# UNITED STATES PATENT AND TRADEMARK OFFICE

10/517,940

Oren Globberman

<b>Office Action Summary</b>	<b>Application No.</b> 10/517,940	<b>Applicant(s)</b> GLOBERMAN, OREN	
	<b>Examiner</b> JONATHAN A. HOLLM	<b>Art Unit</b> 3734

**Fig. 10**

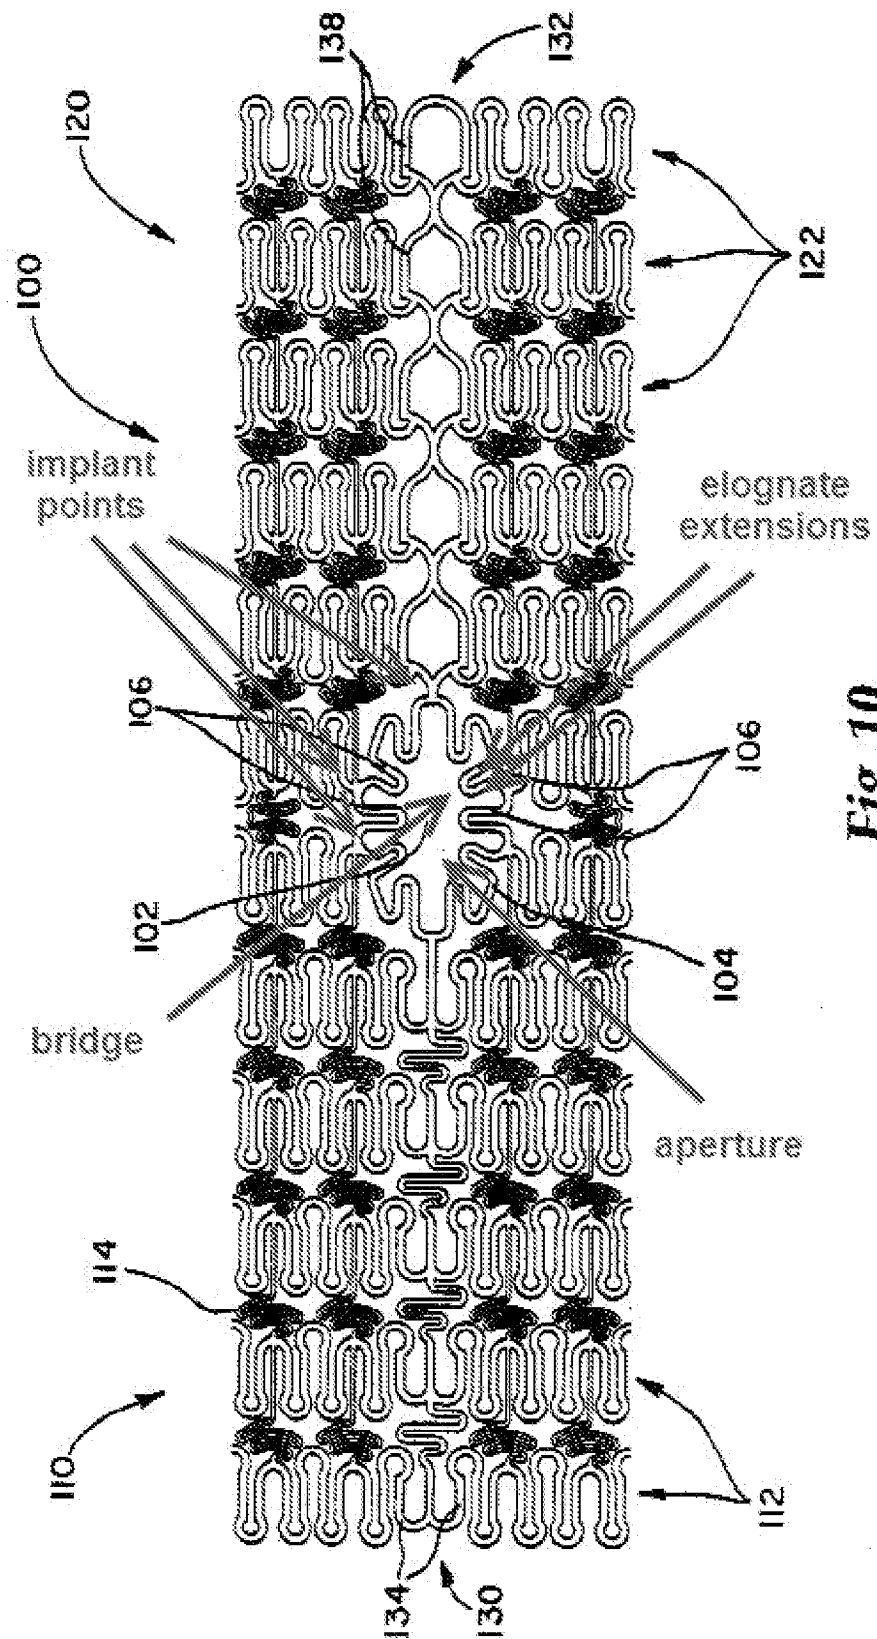
The device of Vardi et al is not explicitly disclosed with at least two hinges defined on at least one of said extensions at least two of which have different preferred bending directions. Shanley teaches providing at least two hinges on an extension having different bending directions (see fig 3e). It would have been obvious to a person having ordinary skill in the art at the time of the invention to modify the device of Vardi et al to include at least two hinges defined on at least one of the extensions, as taught by Shanley, since Shanley teaches that such a configuration allows for more controlled expansion characteristics of the elongate members (column 6, lines 29-54).

The modified device of Vardi et al in view of Shanley is not explicitly disclosed with the hinges being defined on at least one of the extensions to allow a flaring of the at least one extension as an outcome of deformation of the body. Vardi et al teach the extensions being flared out by a balloon (see figure 13f). Vargas et al teach configuring hinges on elongate extensions to allow for flaring of the at least one extension as an outcome of deforming a cylindrical body (i.e., without the use of a balloon to cause the flaring; see figures 3-4; column 4, line 54 - column 5 line 19). It would have been obvious to a person having ordinary skill in the art at the time of the invention to modify the device of Vardi et al in view of Shanley to configure the hinges to allow for a flaring of at least one extension upon deformation of the body, in view of Vargas et al, in order to simplify delivery of device by obviating the need for a balloon to flare the extension in a branch vessel.

Vardi et al teach a method of distorting a cylindrical stent structure having at least two extensions coupled at a point thereof and sized and shaped to be placed in a vascular bifurcation including changing the relative position of two points on said extensions (the implant points (see annotated figure 10 above) are moved relative to each other during inflation of the delivery balloon) that are distanced from the coupling point (see figures 13a-d), but is disclosed with using a balloon to bend the extension instead of transforming, using a plurality of pre-defined hinges, tension forces applied by said changing into forces that bend said structure in a plane outside of a plane defined by said changing. Vardi et al teach transforming, using a plurality of pre-defined hinges, tension forces applied by changing the relative position of points on extensions coupled to each other into forces that bend the extensions outside of a plane defined by the changing (i.e., without the use of a balloon; see figures 3-4; column 4, line 53 – column 5, line 9). It would have been obvious to a person having ordinary skill in the art at the time of the invention to modify the method of Vardi et al to transform, via a plurality of hinges, tension forces applied by said changing into forces to bend said extensions in a plane outside of a plane defined by the changing, in view of Vargas et al, in order to simplify delivery of device by obviating the need for a balloon to flare the extension in a branch vessel.
